OSMRE oversight Inspection Report, Partial Inspection, New Elk Mine C-1981-012

Attached for your records is a copy of the Division's Inspection Report for the OSMRE oversight-Partial Inspection of the New Elk Mine (C-1981-012) conducted on February 15, 2024.

Permit Numb	oer: C-1981-012
Mine Name:	New Elk Mine

Photo 6: Scouring around inlet of C65

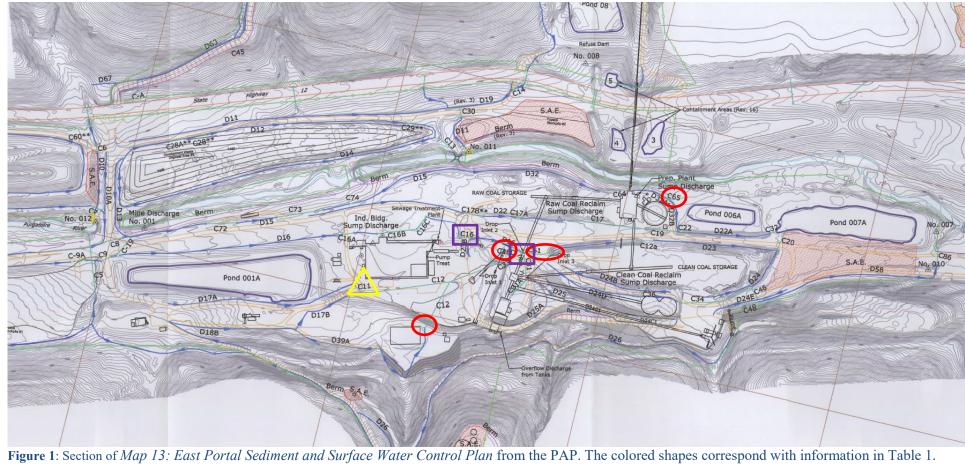
- The measurements for the culverts leading up to, within, and around the RDA were not collected during this inspection.
- After the inspection concluded, it was discovered that culvert C11 was missed on accident, therefore no field measurement has been obtained at this time (see Figure 1).
- > The items in red on Table 1 identify maintenance items for culverts C12, C14, C16D, C61, and C65. See Photos 1-3 and 6. Also, see Figure 1 for approximate locations of these issues.
